ServiceInfo 6/2026

Recommendations for systems equipped with LPA-8 and LPE-8 vehicles

Fig. 1 Illustration of the retrofit kit fitted to the chair

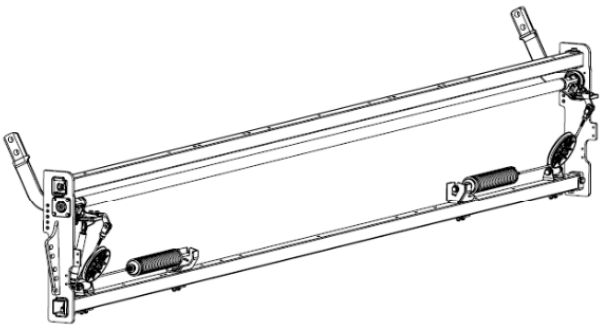
following the positive results achieved with the new spring system developed for certain chairlift models, LEITNER has introduced Retrofit kits for the locking bars of the LPA-8 and LPE-8 series. These kits are available as a retrofit solution to improve the reliability of the locking system.

Technical background
Spring failures in the locking bar mechanism have been reported on some installations with LPA-8 chairs, particularly on models fitted with a single footrest. In response, LEITNER developed a new spring system, successfully validated on the RE-8 series and subsequently adapted for the LPA-8 and LPE-8 series.

- Reduces the risk of spring failure in the closing mechanism.
- Improves the operational reliability of the safety bar.
- Aligns the technical solution with LEITNER's latest standards.
- Extends the system's service life and reduces unscheduled maintenance.
